**GEORGETOWN-SCOTT COUNTY PLANNING COMMISSION**  
**AGENDA**  
**MAY 15, 2025**  
**6:00 p.m.**

# DUNCAN PROPERTY FINAL SUBDIVISION PLAT

## Staff Report to the Georgetown-Scott County Planning Commission May 12, 2025

**COUNTRY BOY - HI-VIEW  
6325 CINCINNATI PIKE  
PRELIMINARY DEVELOPMENT PLAN**

PRELIMINARY DEVELOPMENT PLAN

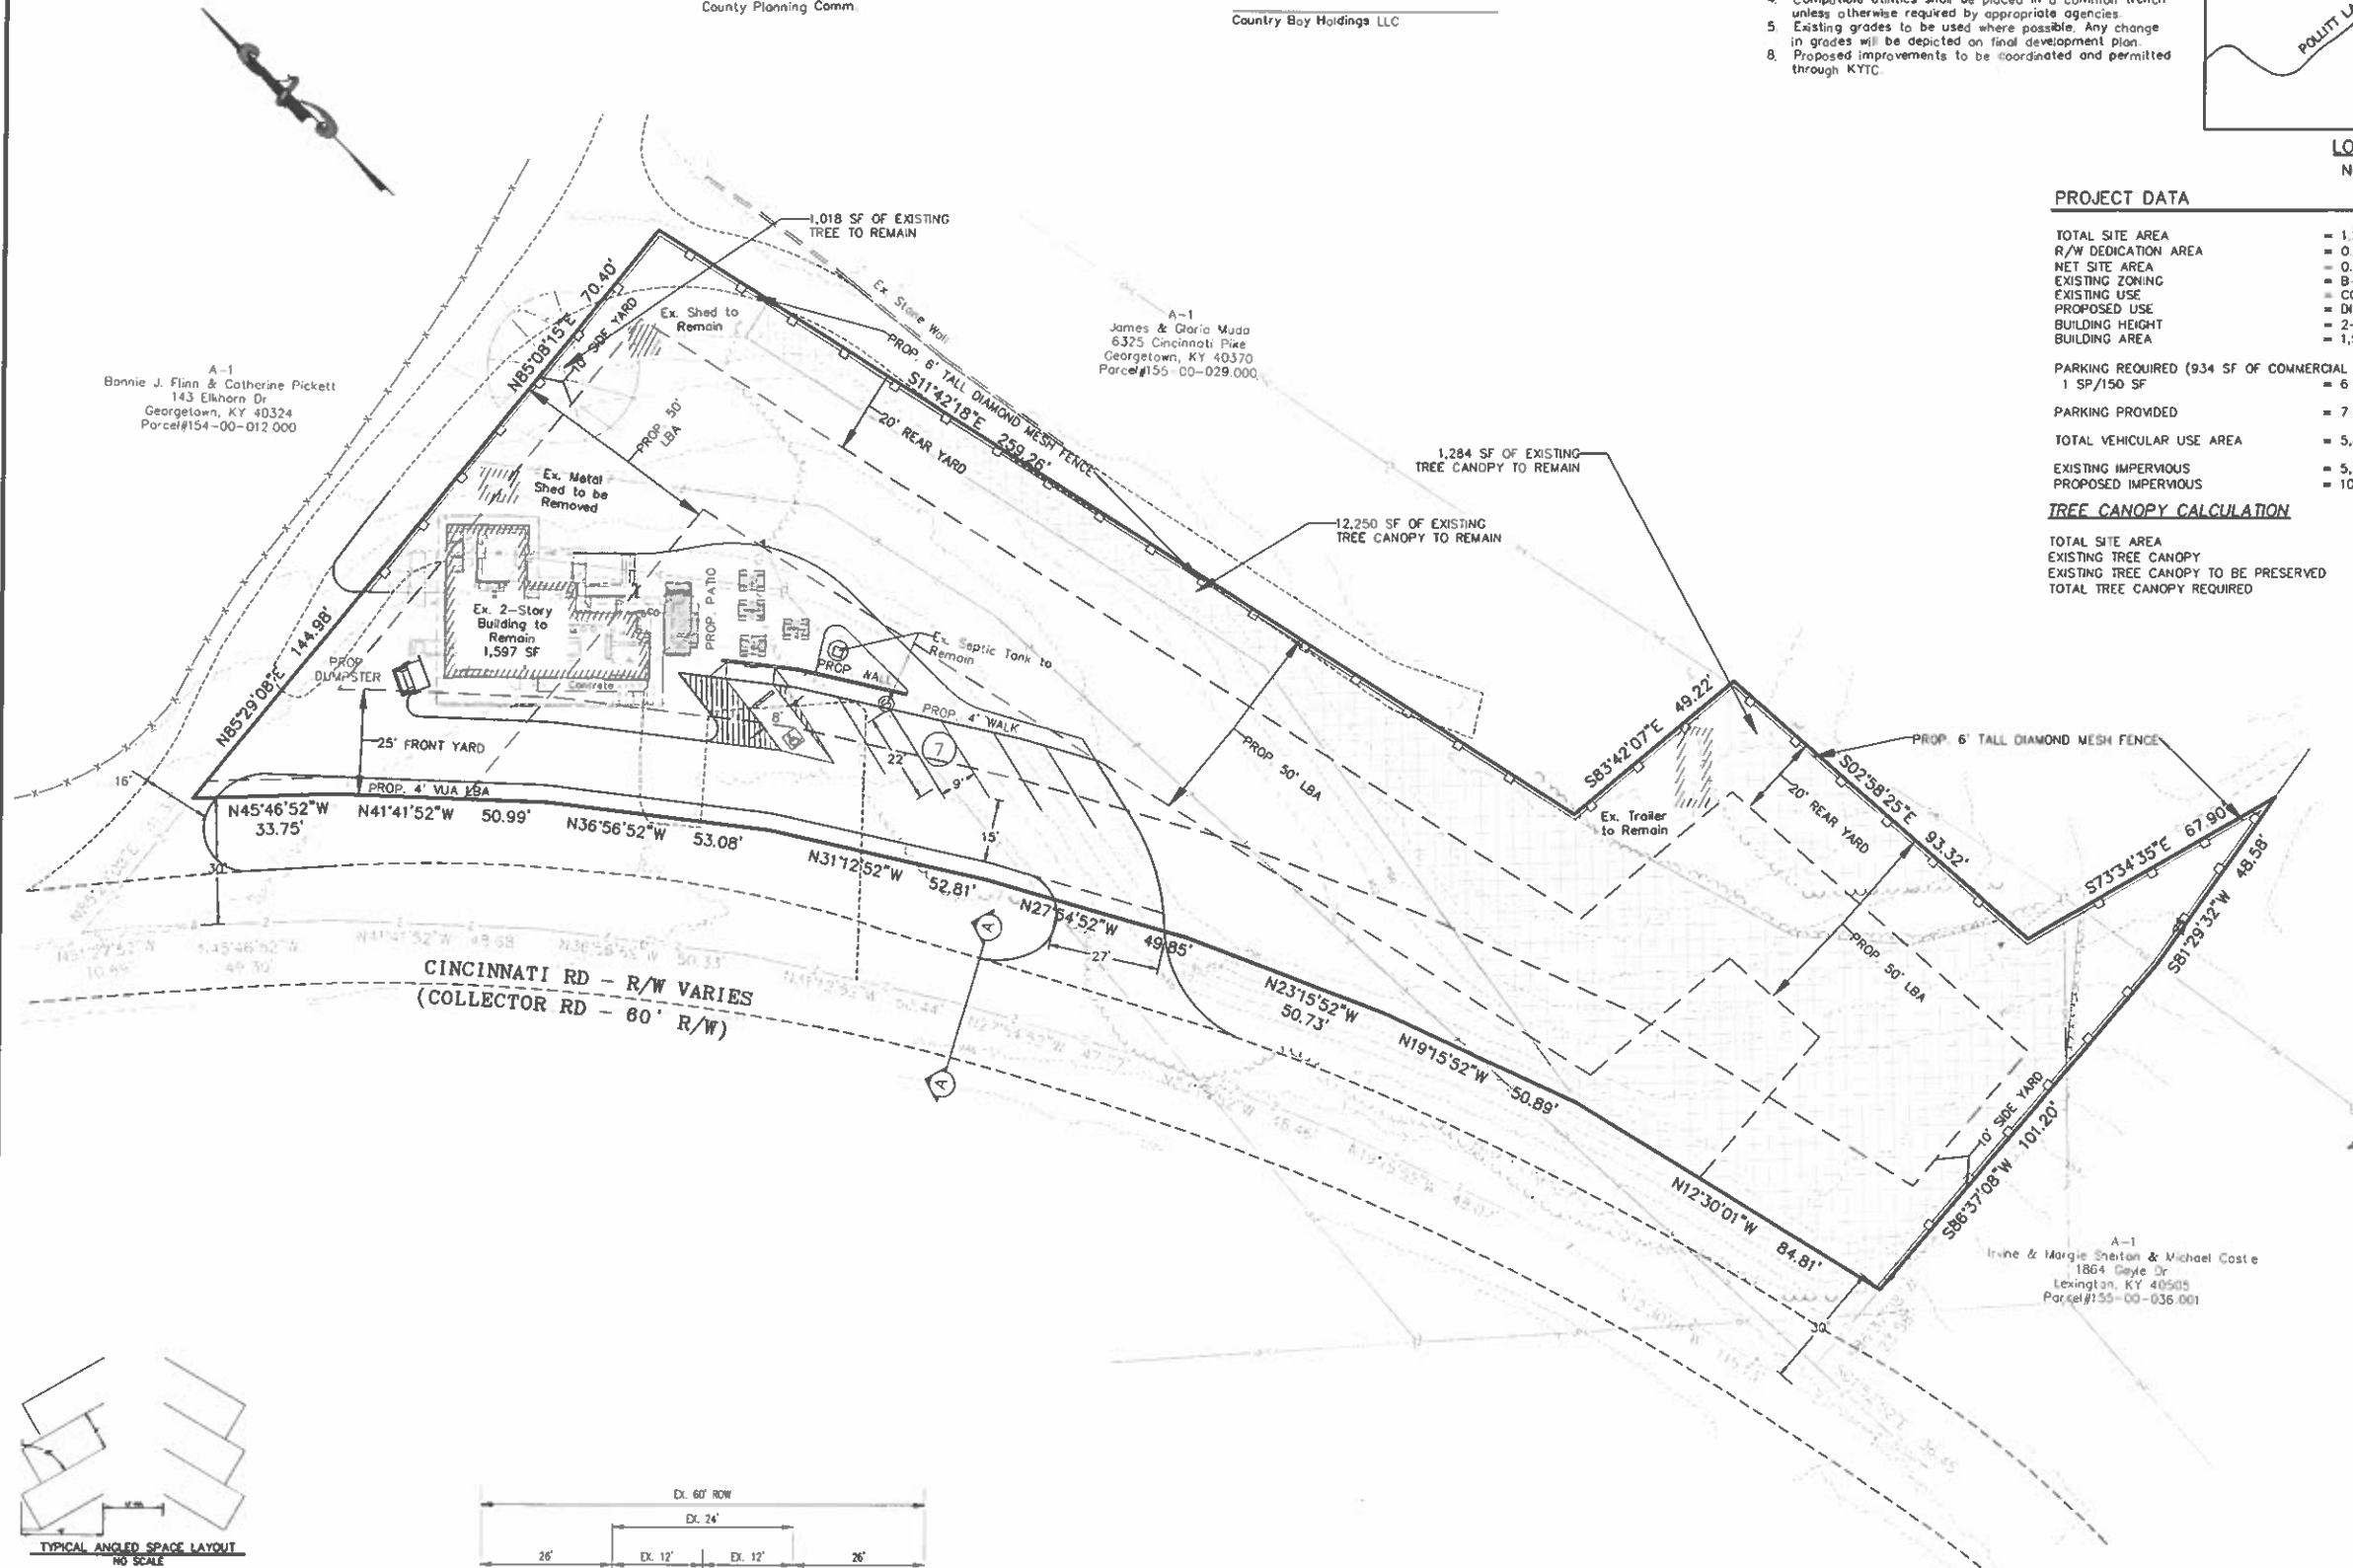
**PARKING REQUIRED (934 SF OF COMMERCIAL FLOOR AREA)**

1 SP/150 SF = 6 SPACES

PARKING PROVIDED = 7 SPACES

4. Prior to any construction or grading, a Final Development Plan, including all required construction plans, shall be approved by the Planning Commission staff and the applicant shall schedule a Pre-Construction Meeting with the Planning Commission Engineering Department to review construction policies and to establish inspection schedules. This includes a Grading Permit with fee and a Land Disturbance Permit with erosion control surety.

7. A photometric plan shall be submitted and approved as part of the Final Development Plan. The Applicant shall direct lighting away from adjoining property and not have any off-site impact.

PRELIMINARY LANDSCAPE PLAN

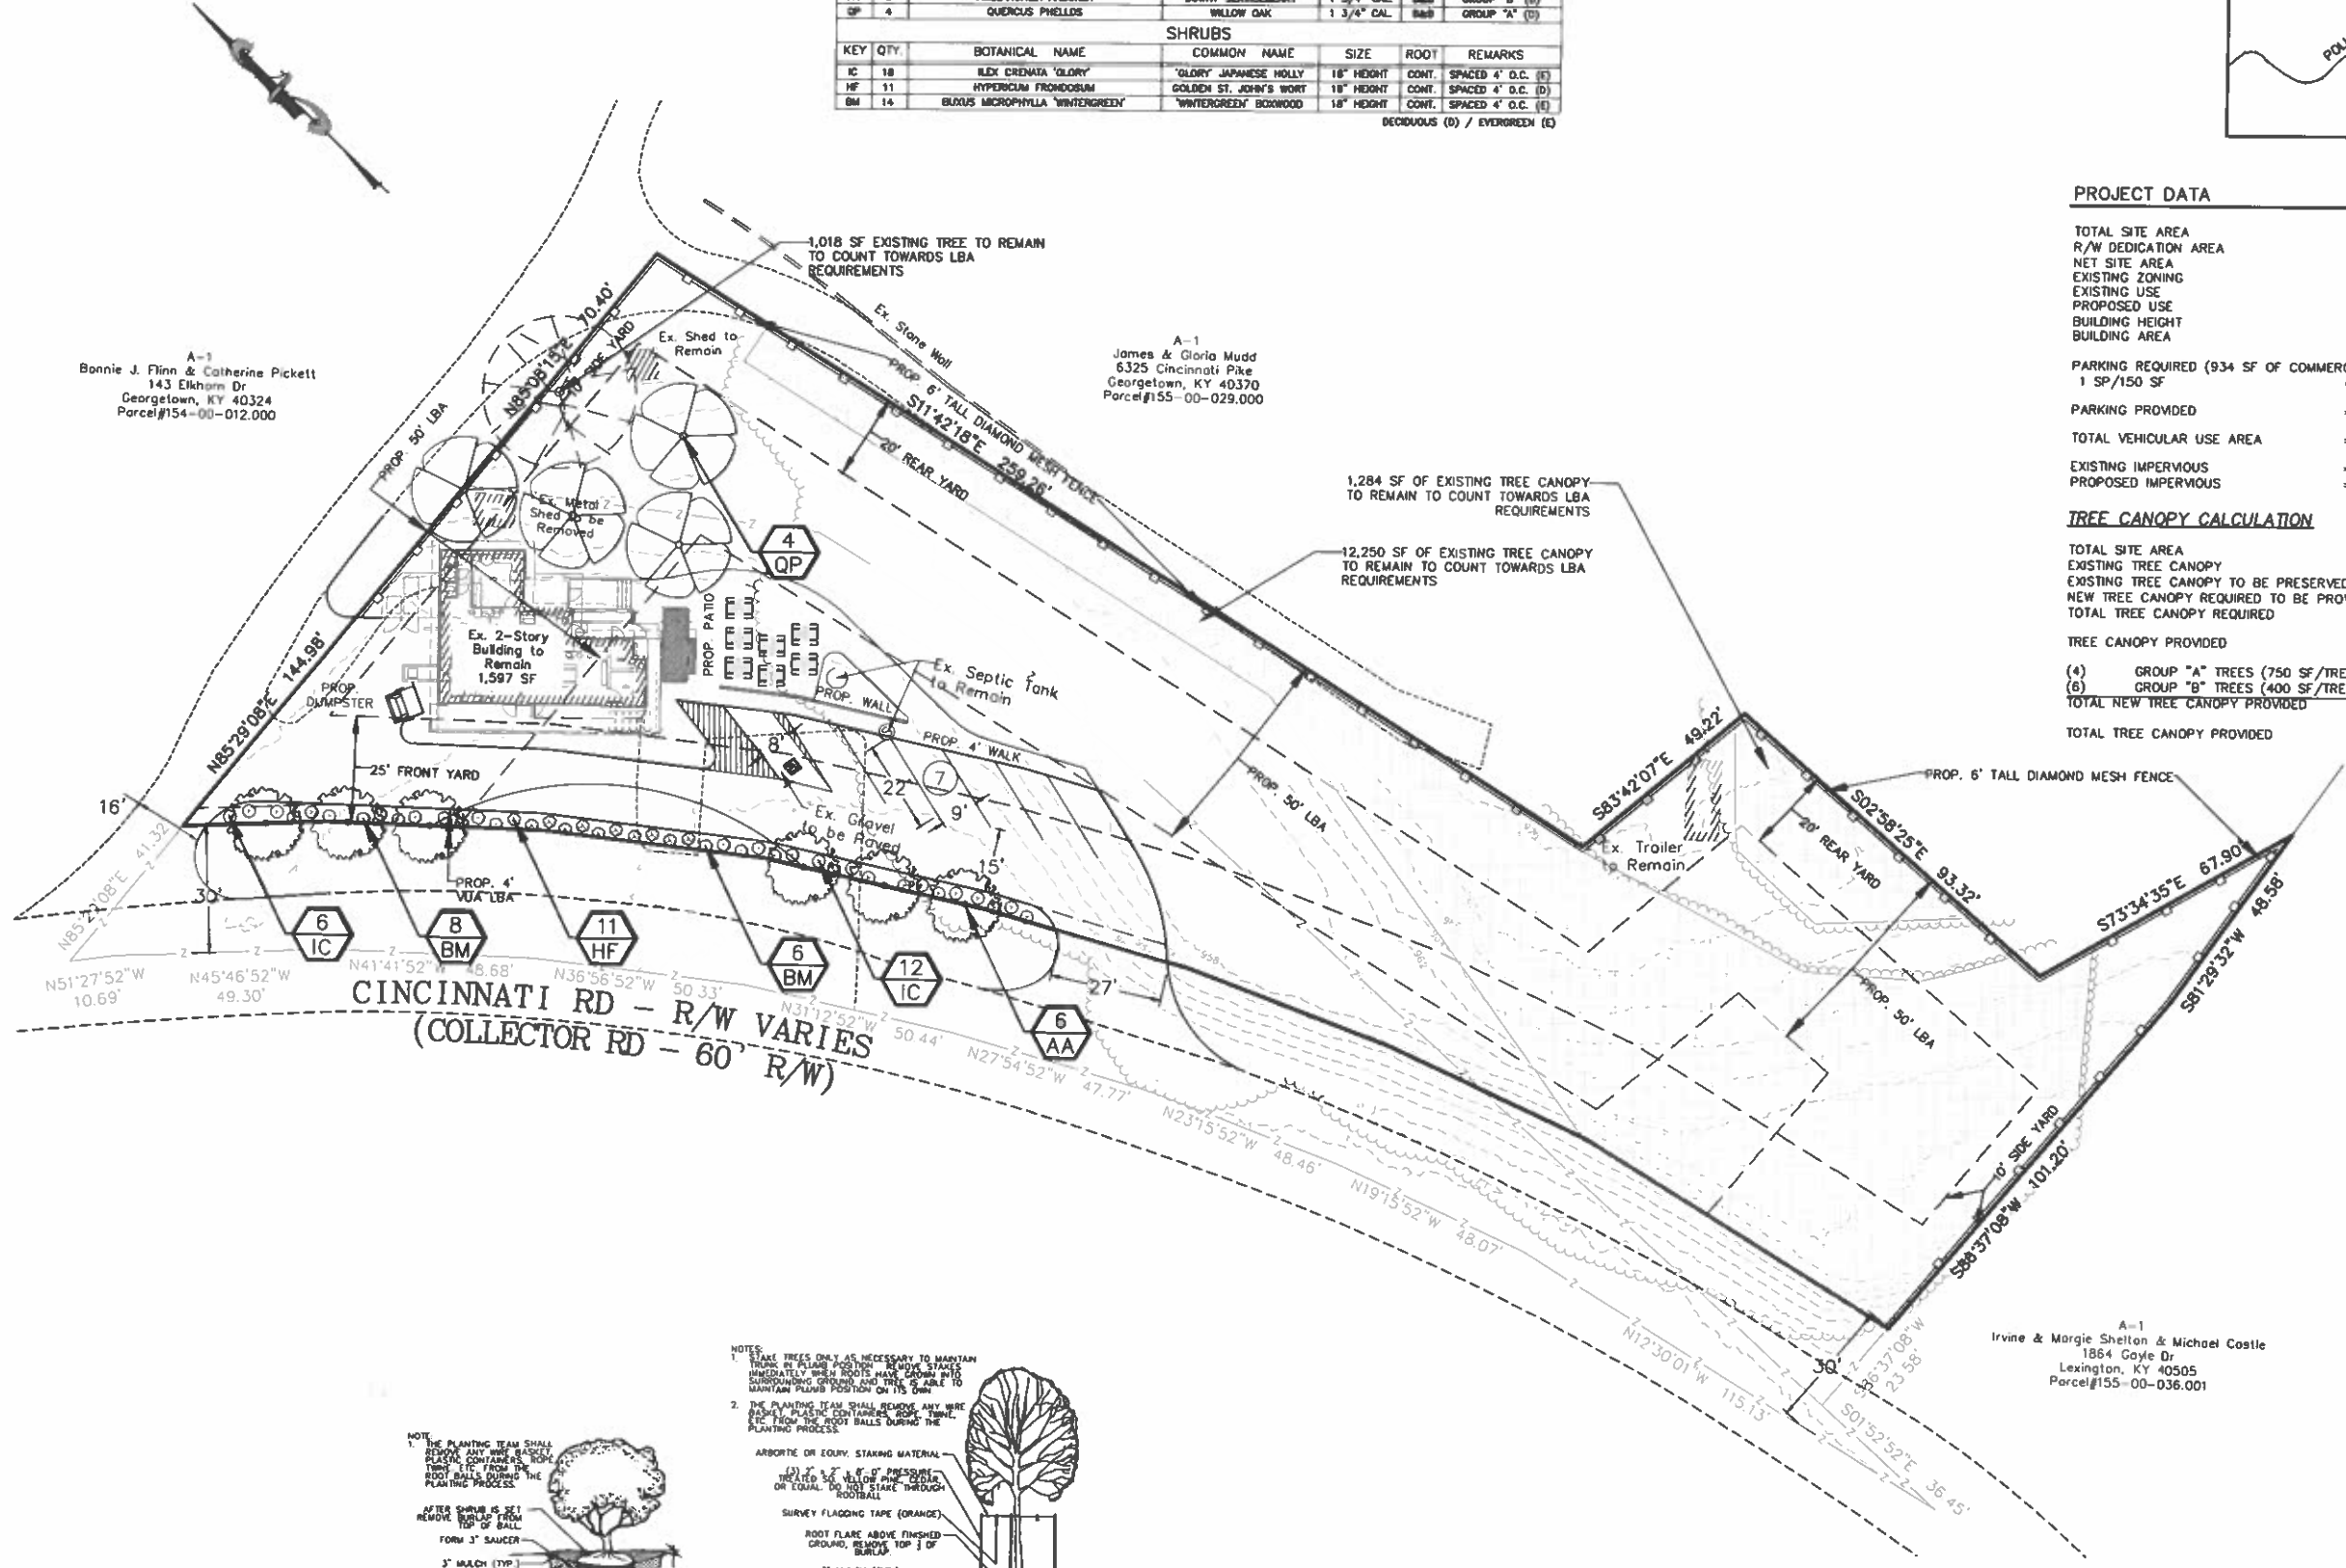
The landscape sheet provided as a supplement to this preliminary development plan meets the requirements of this ordinance.

A species-specific landscape plan shall be included with the Final Development Plan.

8. A species-specific landscape plan shall be included with the Final Development Plan indicating all trees to be preserved during construction.
9. All requirements of the Scott County Fire Department regarding fire hydrant locations and emergency vehicle accessibility.

DATE: 03/28/2025  
JOB NUMBER: 12738.00  
DRAWN: RMT/GST  
CHECKED: GOW  
SCALE: 1"=50'  
SHEET: C-3.0

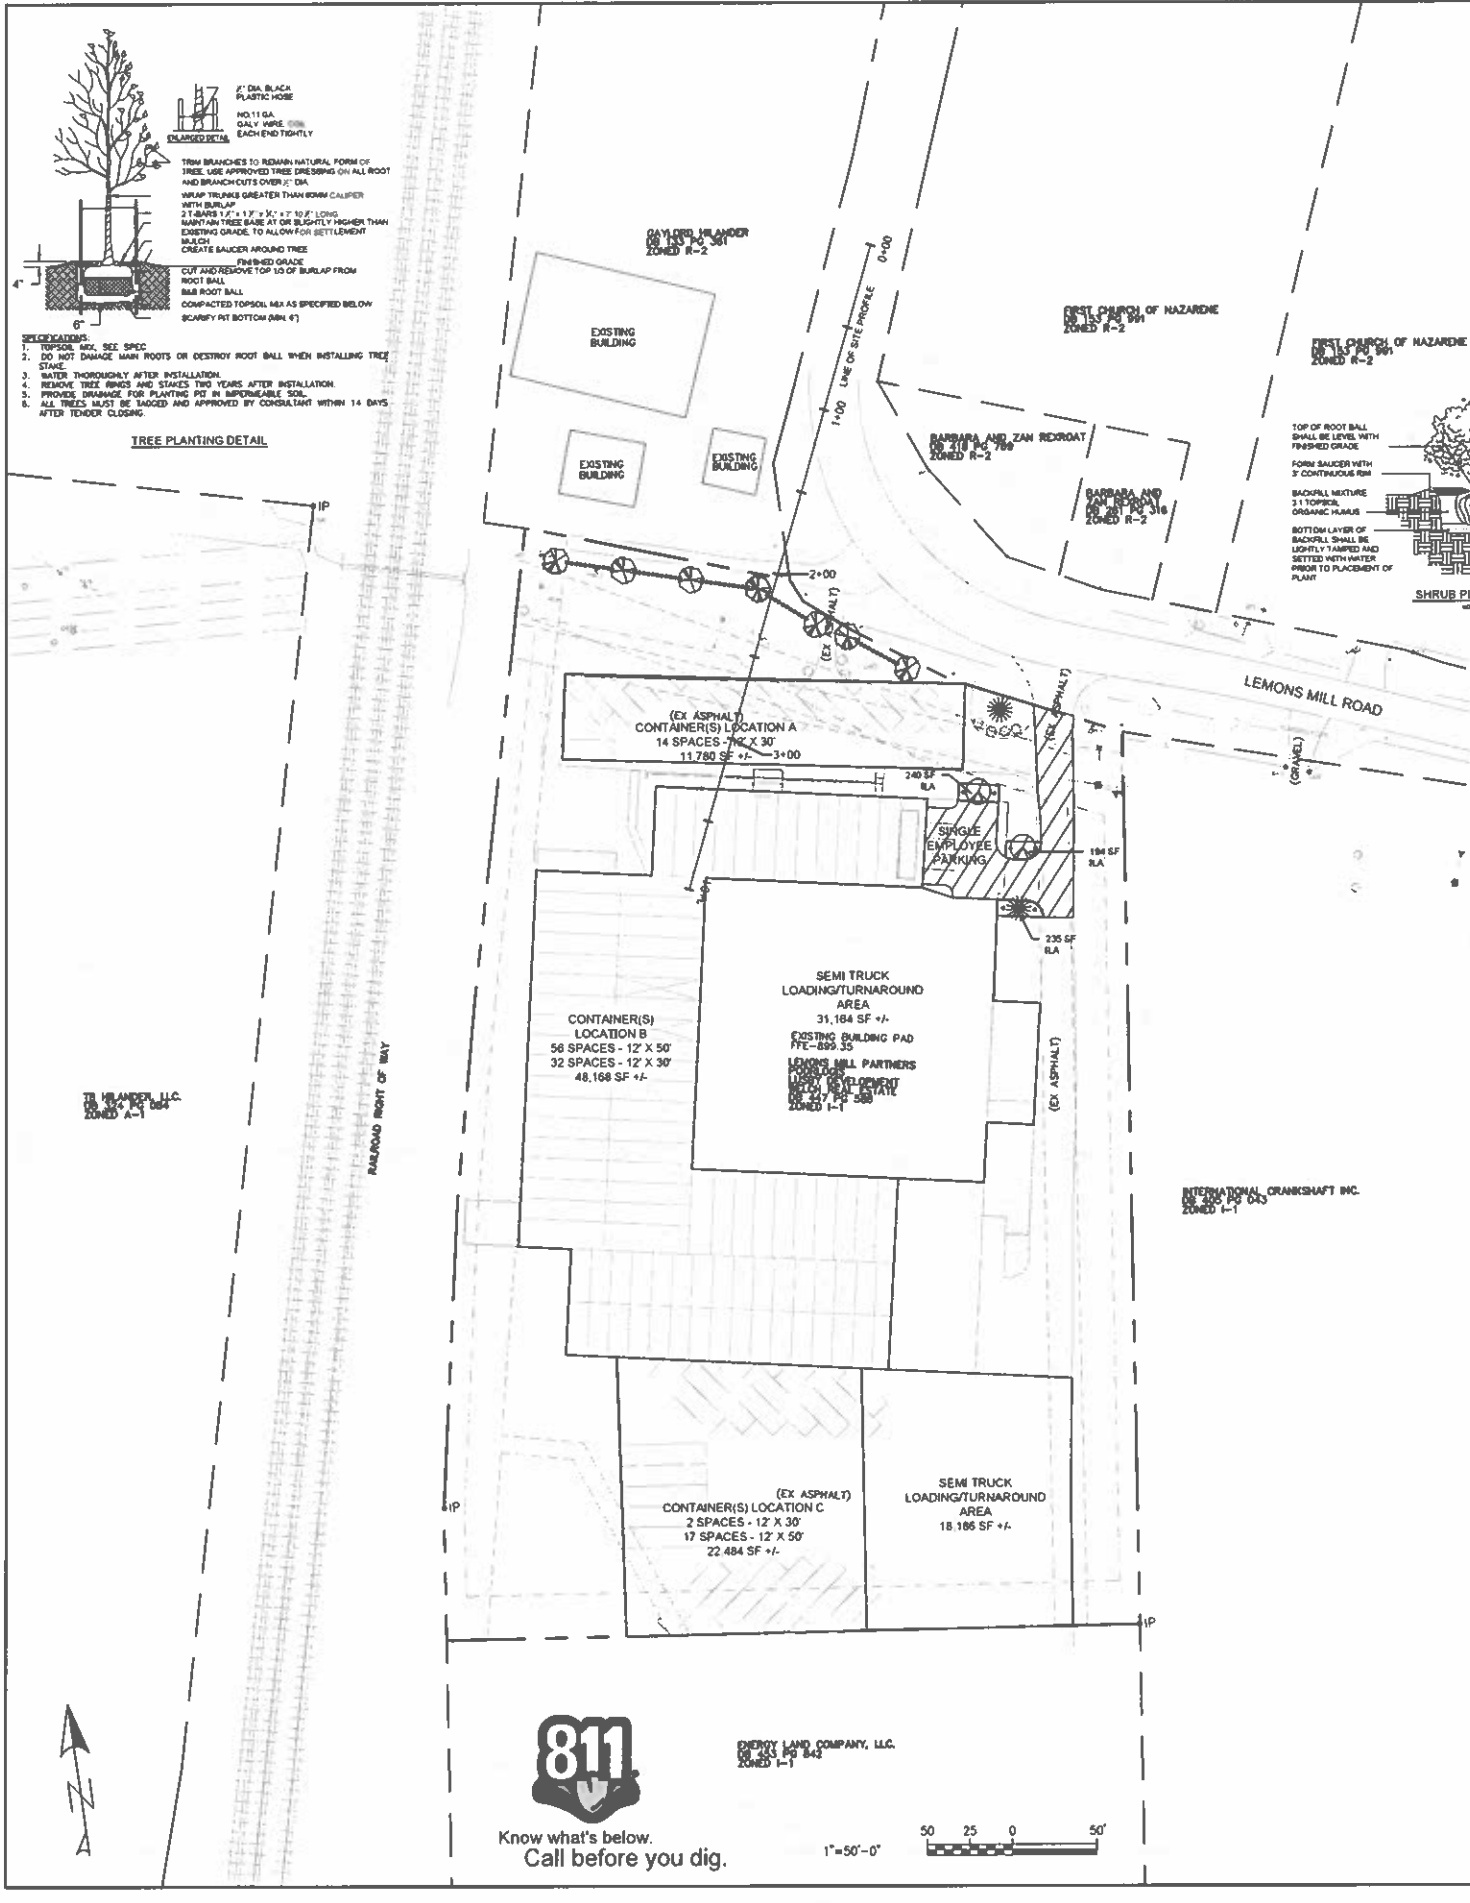
The landscape sheet provided as a supplement to this preliminary development plan meets the requirements of this ordinance.

A species-specific landscape plan shall be included with the Final Development Plan.
